**Coordination Act Report
Flood Control Features for Bechara Industrial Area
Rio Puerto Nuevo Flood Control Project**

**Felix Lopez
US Fish and Wildlife Service
Boqueron, Puerto Rico**

Photo 1. Eastern levee route near Bechara Canal, tall vegetation at the right is the mangrove wetland to be isolated by the levee.

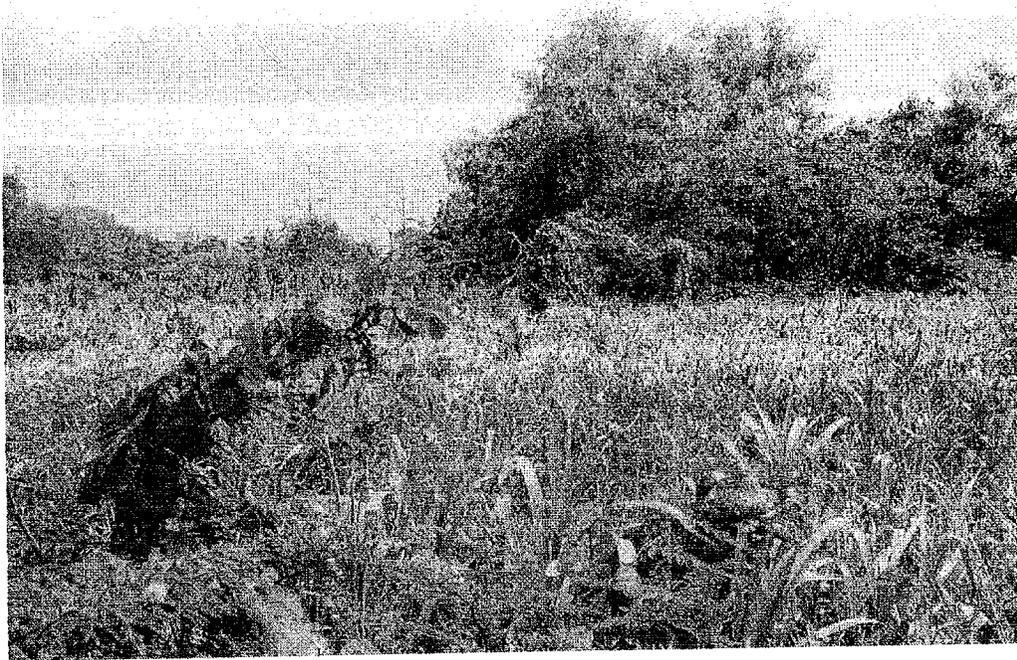
The Service recommended in the past that the Margarita levee be relocated north, to be adjacent to the BIA. Although this would impact additional mangrove wetlands it would act as a physical barrier to the BIA from further expansion into wetlands. The current design will isolate several acres of basin mangroves between the BIA and the levee. The Service believes that the loss of functional value of these wetlands isolated by the levee should be included in the calculations for compensatory mitigation.

Photo 3. Project Plans showing Margarita Levee and mangrove to be isolated between the proposed levee and the Bechara Industrial Area

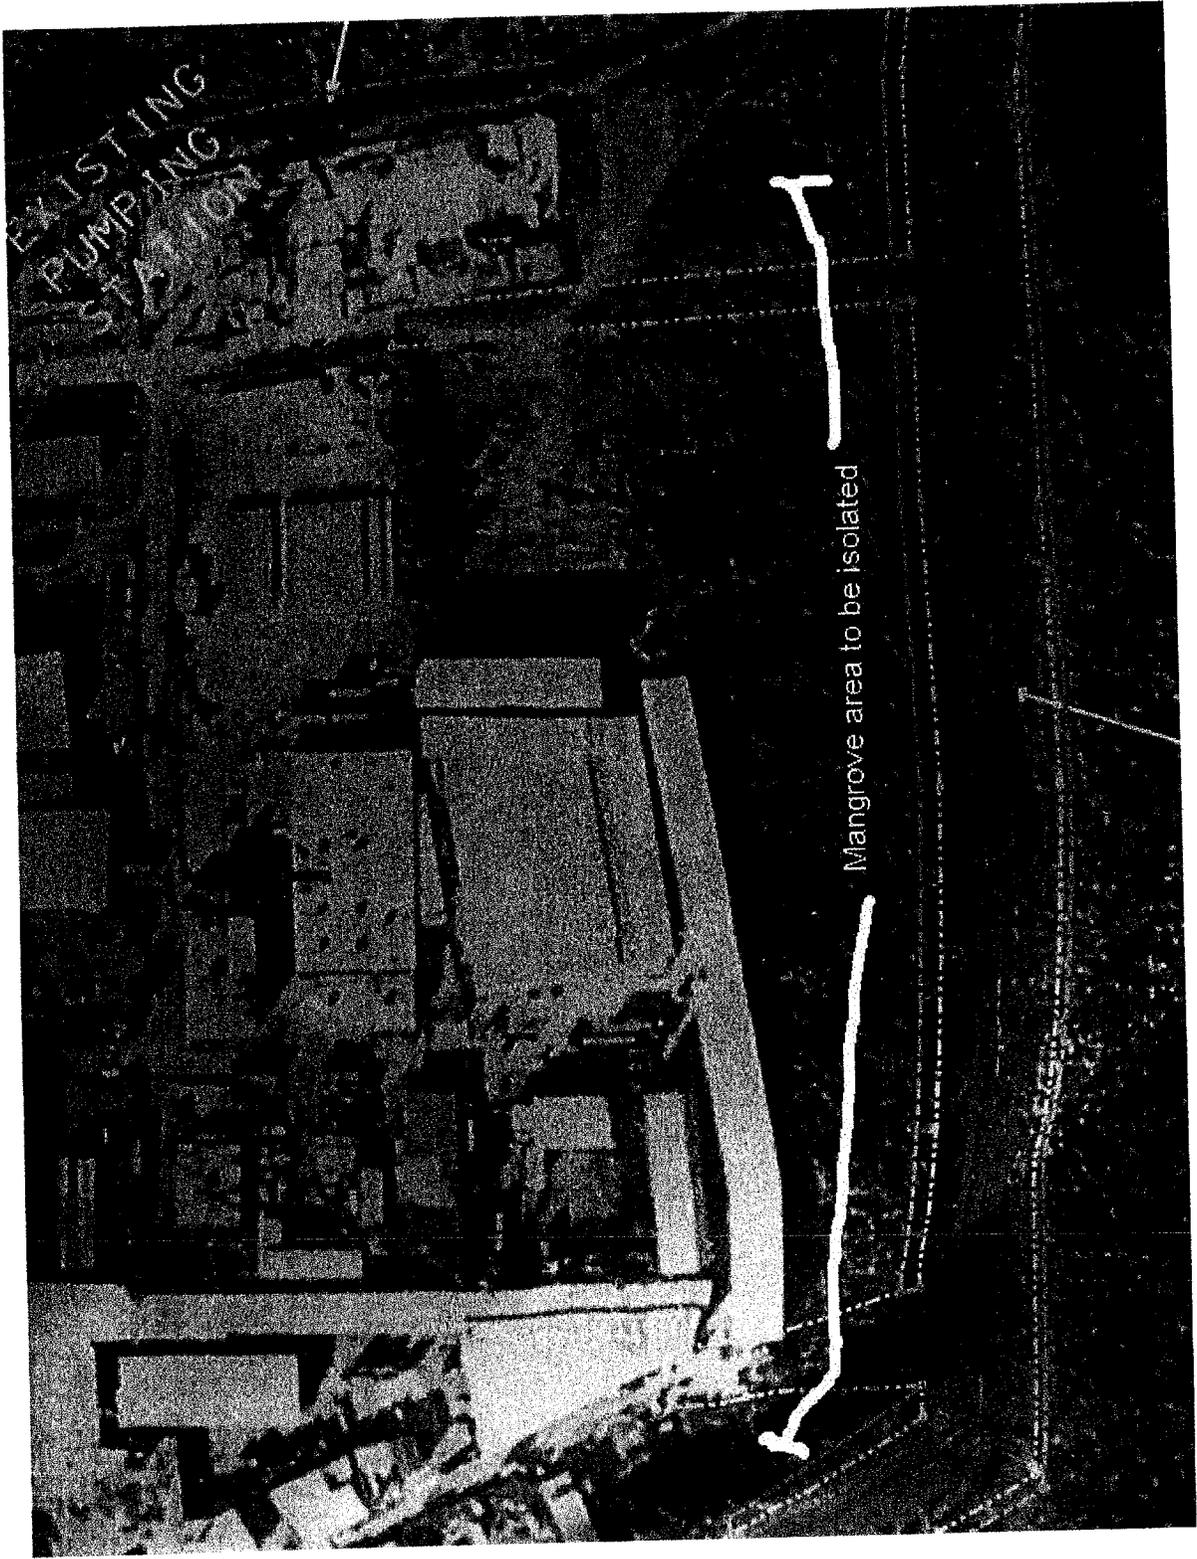
The proposed levee will follow the existing PR Power Authority electric power line right of way. Vegetation here varies from cattails and leather fern (*Acrostichum spp*) in the lower portions to vine covered grasslands in the higher portions. This area is highly disturbed by the regular maintenance of the power lines (See photos 1 & 2). An estimated 7.5 acres of transitional wetlands is expected to be impacted by the levee. North of the proposed levee is a basin mangrove comprised mostly of black mangroves (*Avicennia nitida*) and leather fern with some white (*Laguncularia racemosa*) and red (*Rhizophora mangle*) mangroves intermixed. On the upland interface there are West Indian almond (*Terminalia catappa*), African tulip tree (*Spathodea campanulata*), and castor bean (*Ricinus communis*). This basin mangrove will be isolated by the proposed levee and the BIA. Already parts of this mangrove have been impacted by clandestine expansion of the lots in BIA. The latest such expansion was made by the hardware store Maderas 3C which borders the mangroves. The proposed construction right of way will impact a portion of these mangrove wetlands. Since this area will become isolated by the levee construction (see photo 3), the Service believes it should be added to the mitigation calculations. Once the levee provides protection from flooding this area will be the logical

expansion zone for the BIA. To assume that this mangrove will contain its spot of existing regulations after the construction of the levee, is ingenuous.

The Service continues to recommend that the levee be placed adjacent to the southern border of the BIA. Although this would increase wetland impacts those wetlands are the same ones that will be isolated and subject to impacts with the proposed design. A mitigation plan which is still not selected, should be developed as soon as possible. Mitigation should be integrated with the existing Puerto Nuevo Project.

Photo 4. Fill placed by Maderas 3C to expand their industrial lot. Levee access ramp will be located through this fill.

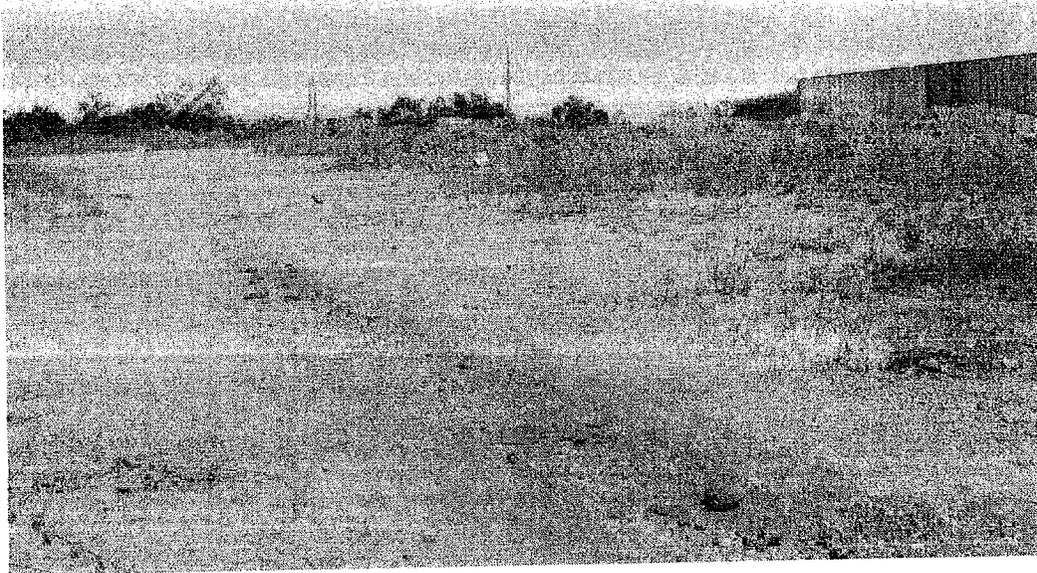
The proposed levee plans call for two main access ramps from the BIA. This will bisect a lot that belongs to Maderas 3C. Based on aerial photos, this area was most likely mangrove wetlands at one time and may have been illegally filled (see photo 4). Representatives from the hardware store indicated that they have plans to use this lot for future expansion or to rent. We recommend shifting the east ramp to an existing roadway which provides access to the Bechara canal. This roadway is clearly visible on the project aerial photographs and is an existing right of way.
